## ADDENDUM

NO. 3

**PROJECT NAME:** Johnson High School 2025 Additions and Renovations

**ADDENDUM DATE:** 15 May, 2025

PACKAGE		VOLUME	
Job No. 1954-07-01	Drawn By: LAFF	Sheet No. ISSUE FOR BID	S4.11
Date: 04/22/2025

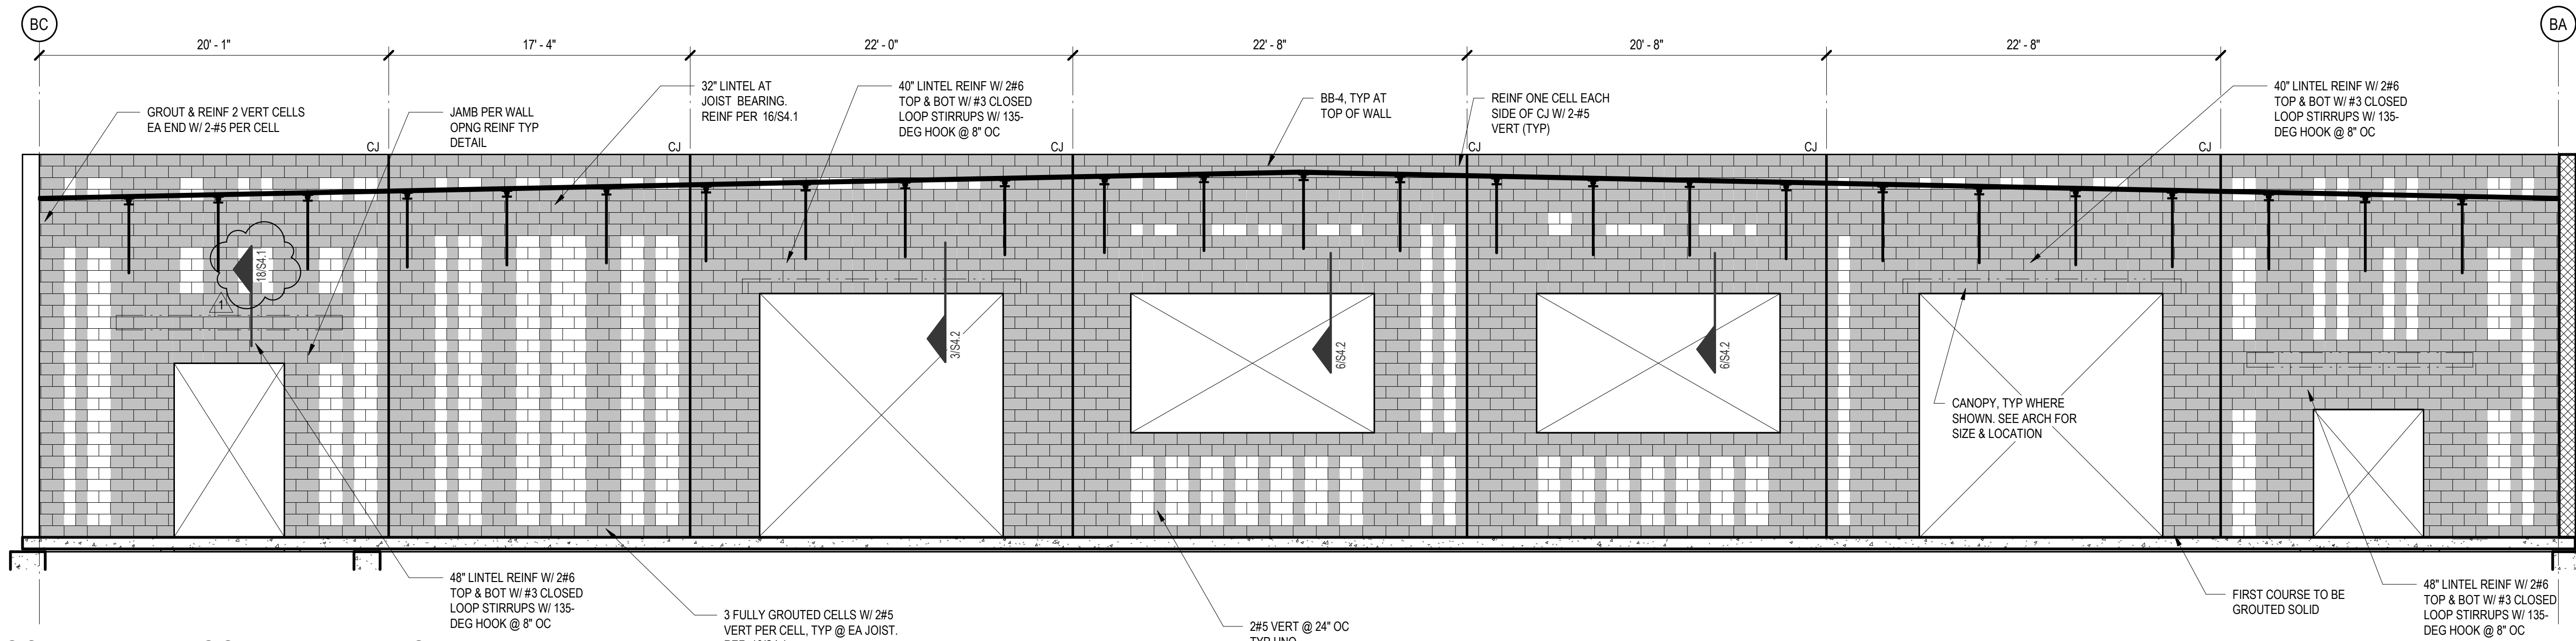
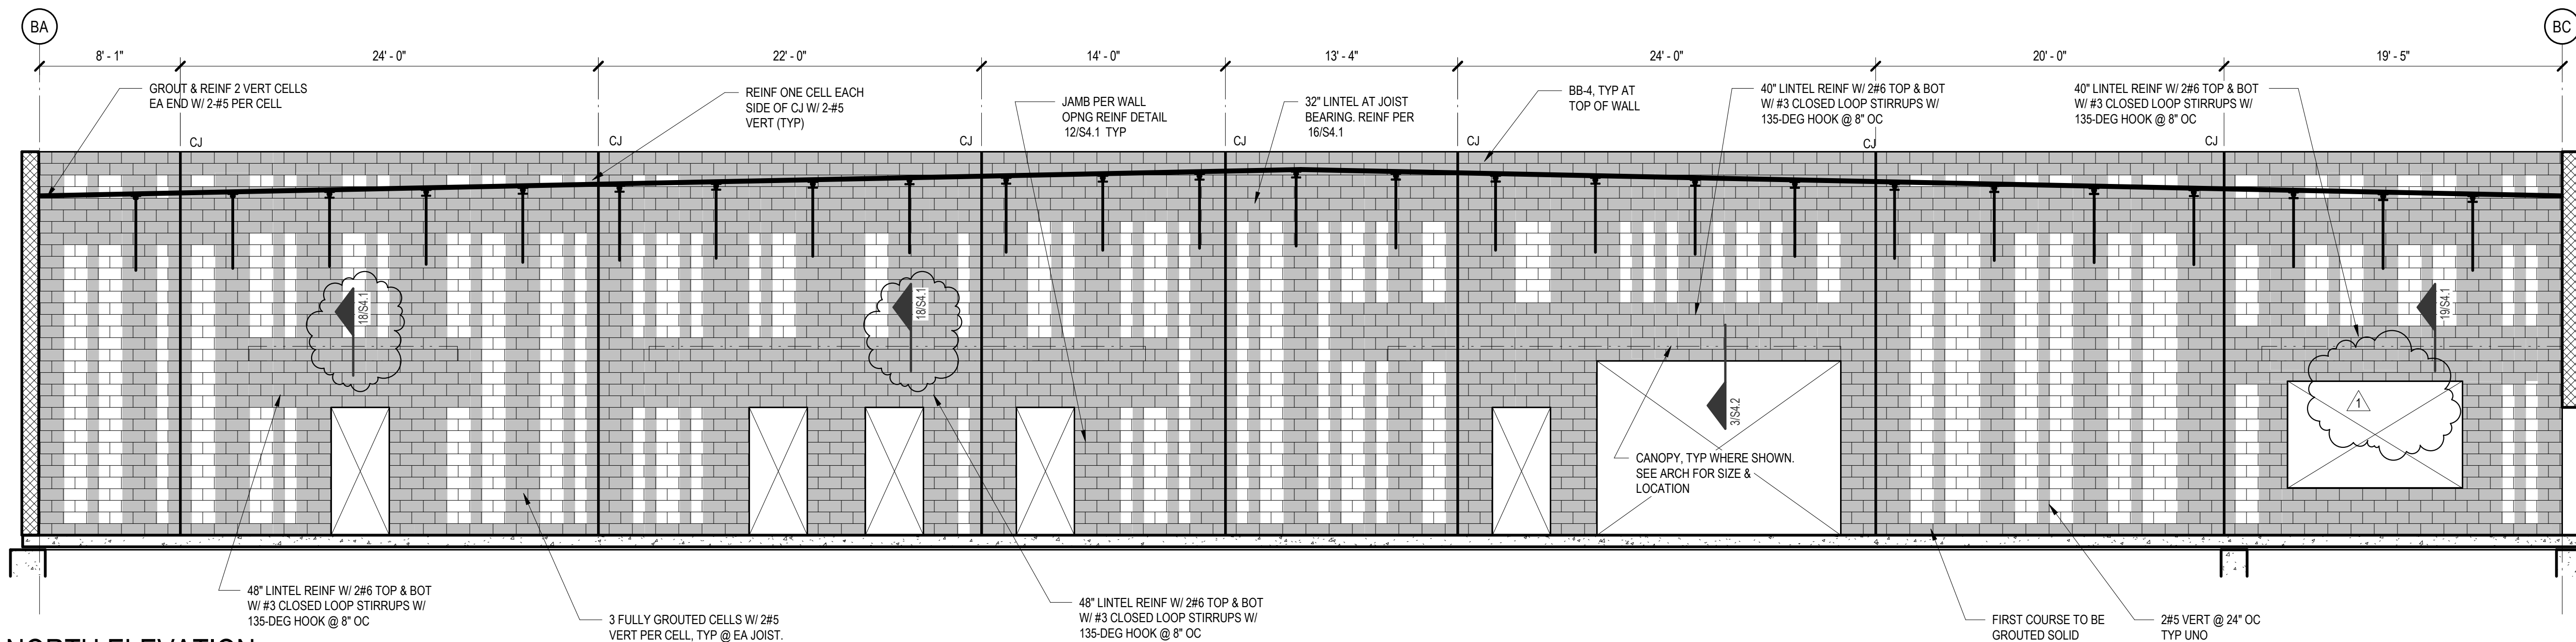
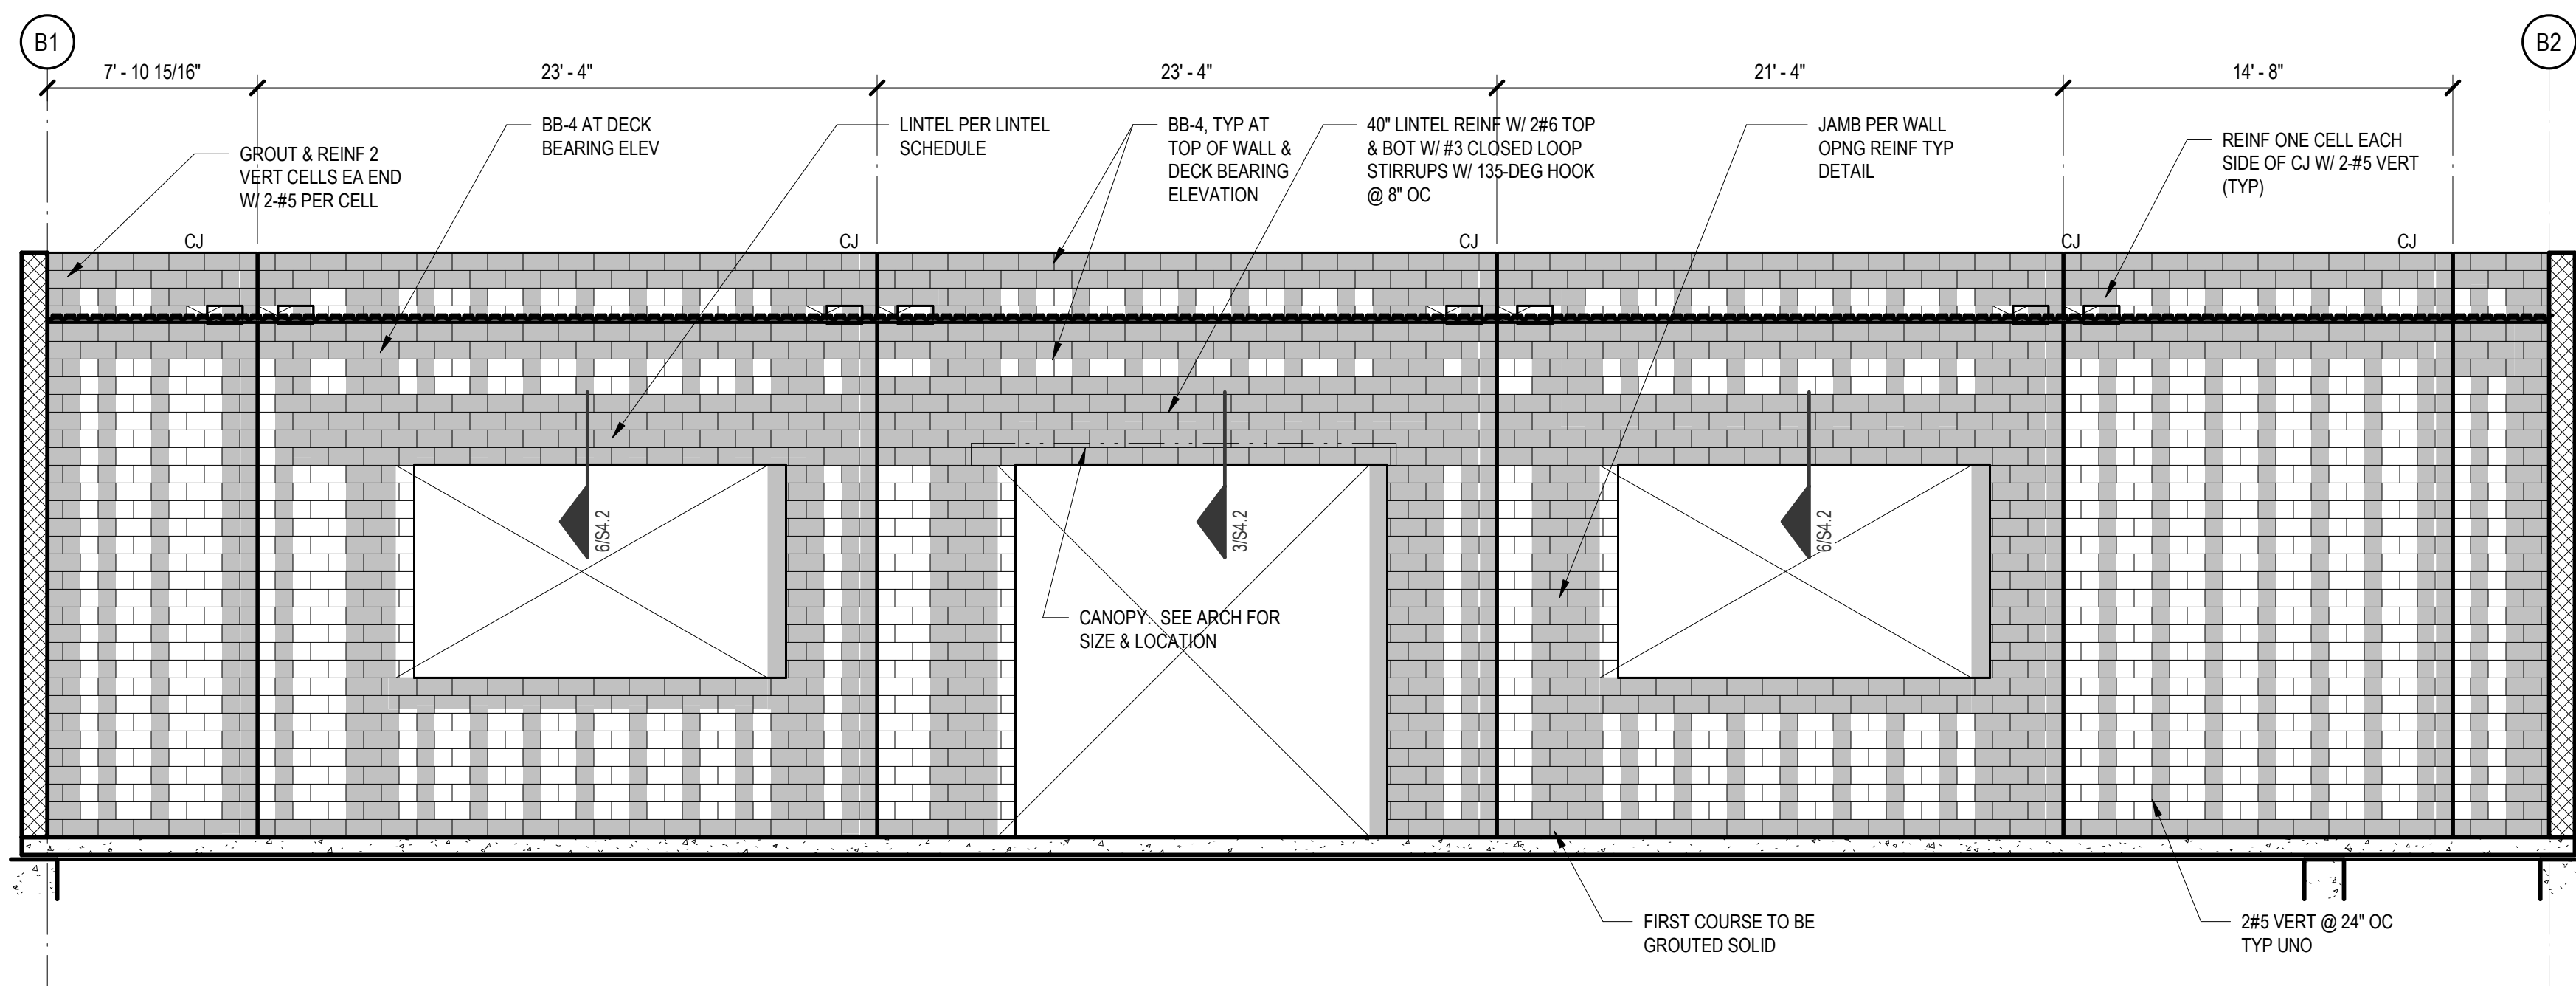
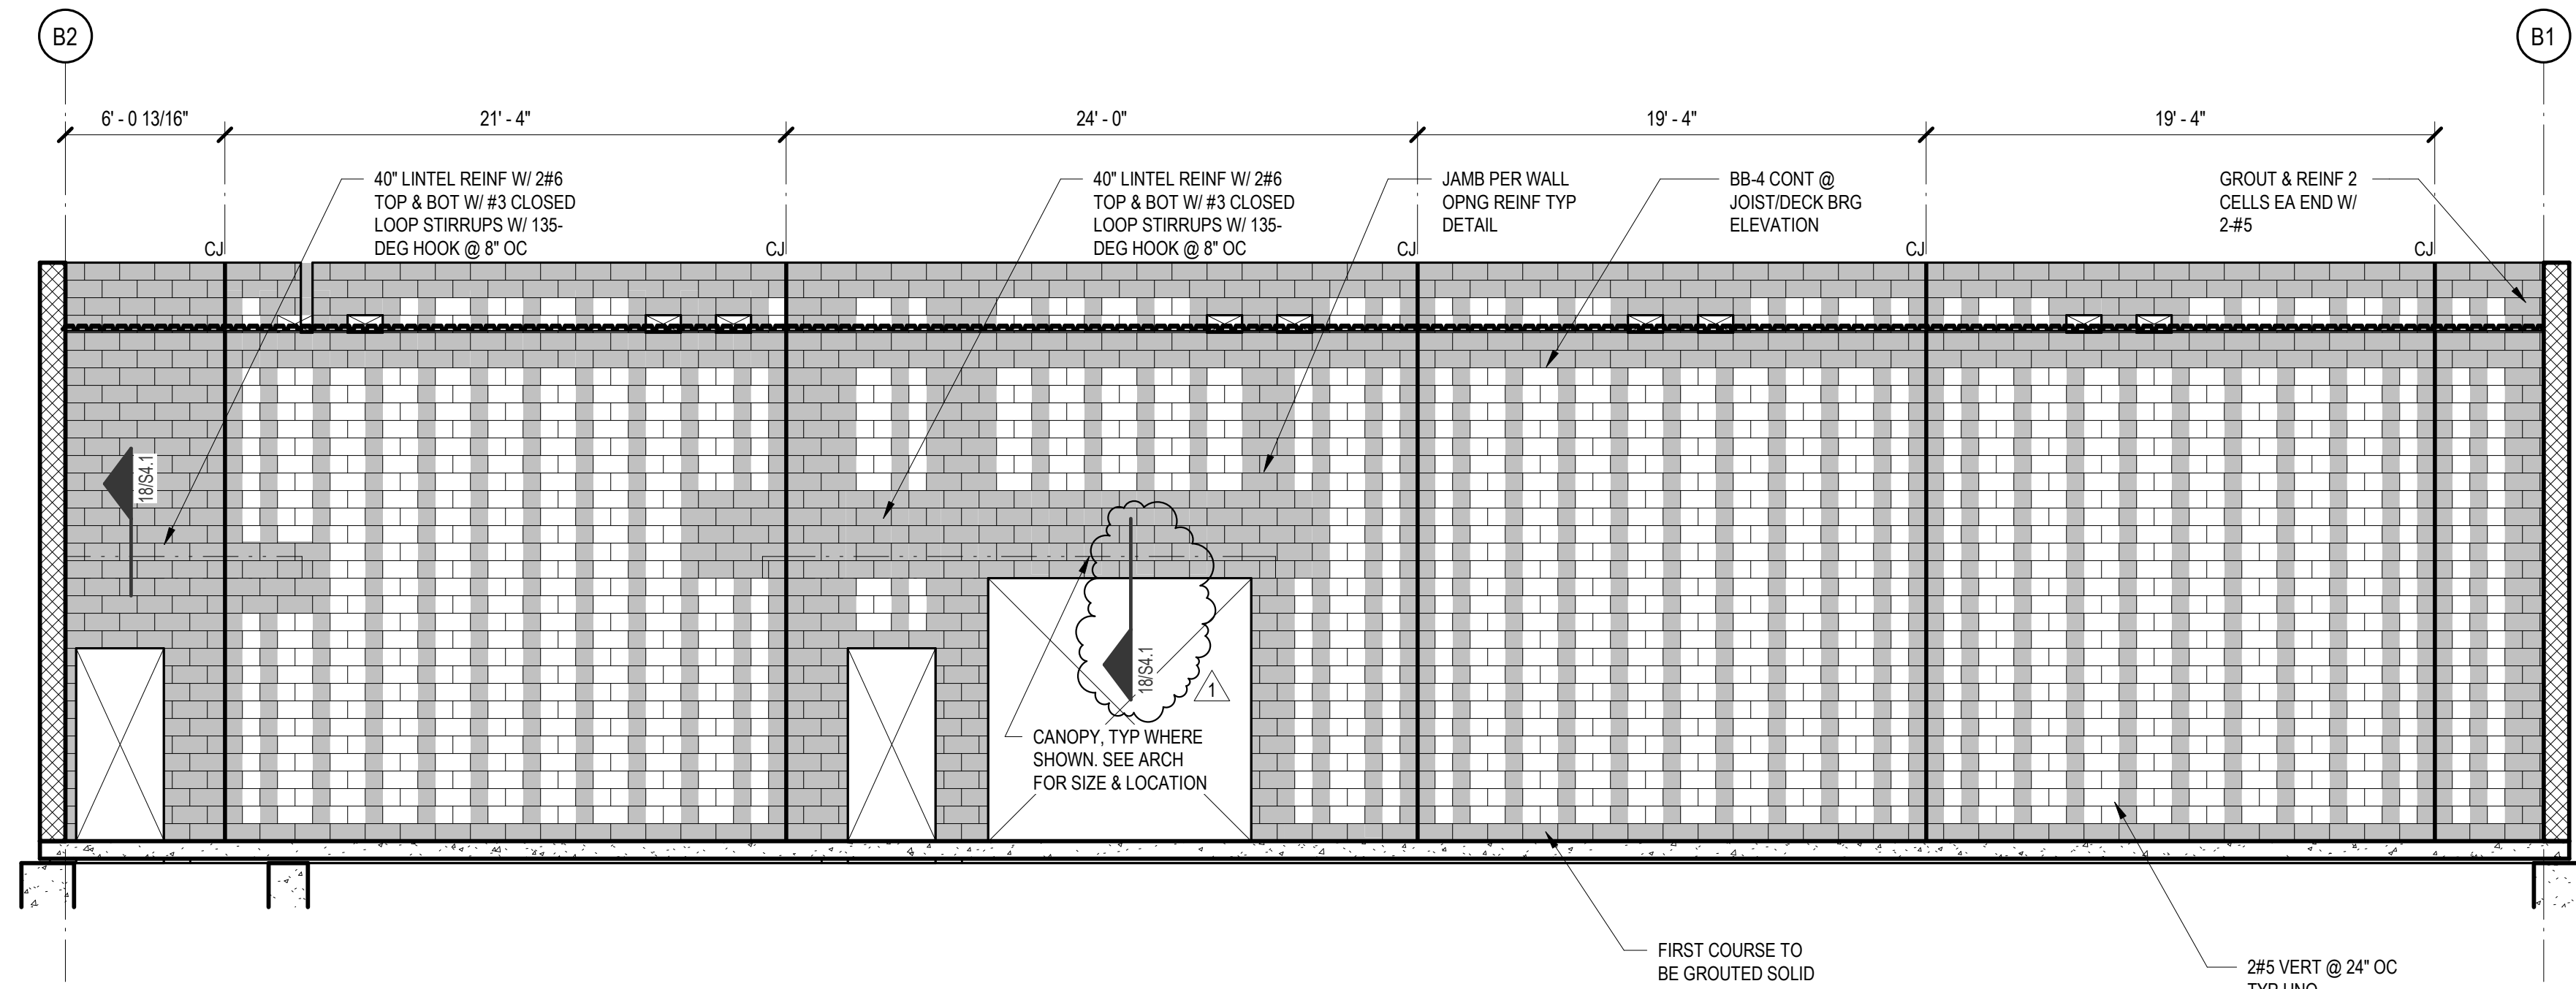
**AD No 3, Struct Item 8: To the Drawings, Sheet S4.11 "MASONRY WALL ELEVATIONS"**

- 1) Revised wall details.
